Request for Well and Septic Service

PRE-PERCOLATION INVESTIGATION REPORT

RE: 795 Watertrough Road
Sebastopol, CA 95472
APN: 076-071-019
SEV07-1015

Site Map: Testing (dry weather)

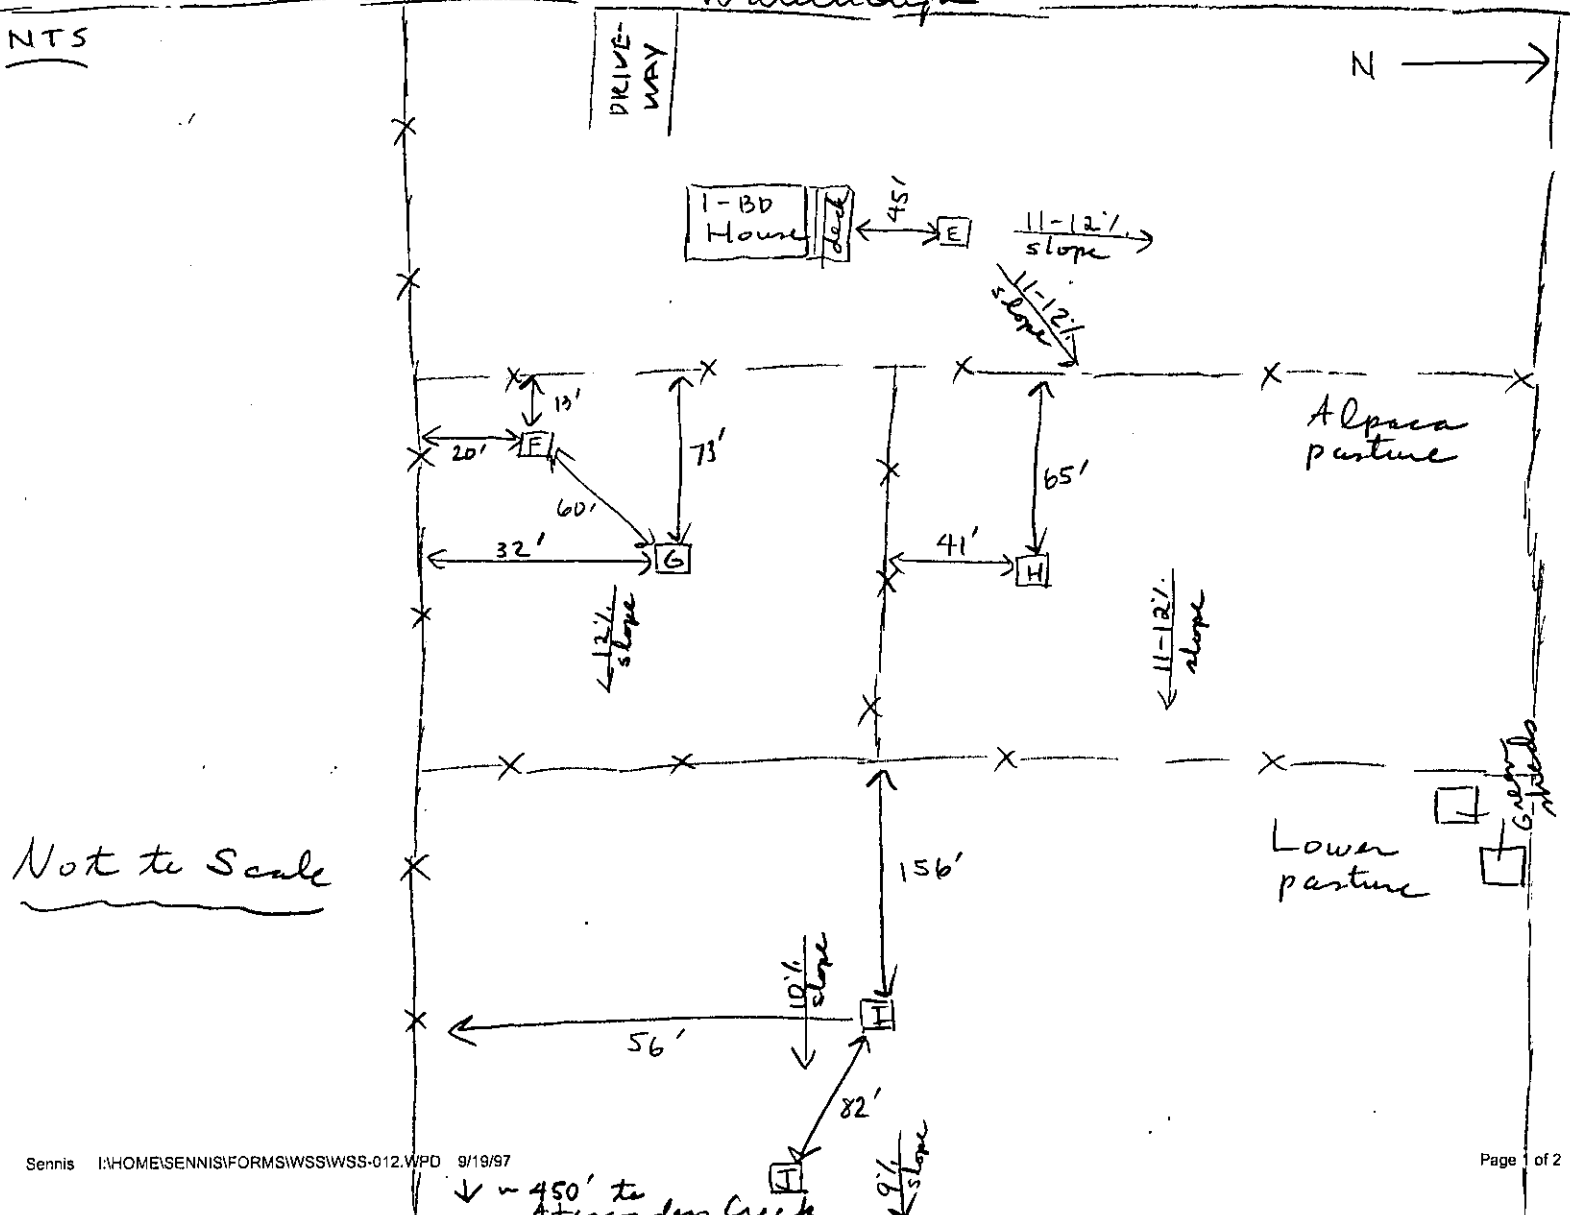
A site inspection was conducted with you on October 9, 2007 to find a suitable area to install a Class 1 system for the addition of a new dwelling or a Class 2 system for the remodel of the existing 1-bedroom dwelling. Six profile holes (E - J) were observed and logged (see attachment). The site is within groundwater availability zone 2 and is identified as Goldridge fine sandy loam by the Sonoma County soil survey map.

Based on soil morphology and site conditions, the area of profile holes C through J appear suitable for a standard fill land system with an interceptor drain, sized at 30mpi. Please note that standard systems do not require an operational permit. Percolation testing is not required.

Profile holes C through J would also be suitable for a drip system, mound system or at-grade system with pre-treatment at a linear loading rate of 7 and a soil application rate of 0.56 gal/sq ft/day. Each of these three systems would require an operational permit. For a drip system, drip line installation is recommended at 12". An interceptor drain would be required to be installed. Percolation testing is not required.

Based on the lot's creation prior to October 1971, a 100% reserve expansion area shall be provided for a mound system. However, a 200% reserve expansion area would be necessary for a drip system, at-grade system or standard fill land system. The septic system design shall meet all Sonoma County PRMD requirements and setbacks, including 100 feet from any wells. If you have any questions, please call me at (707) 565-3771 from 8:00-9:00am.
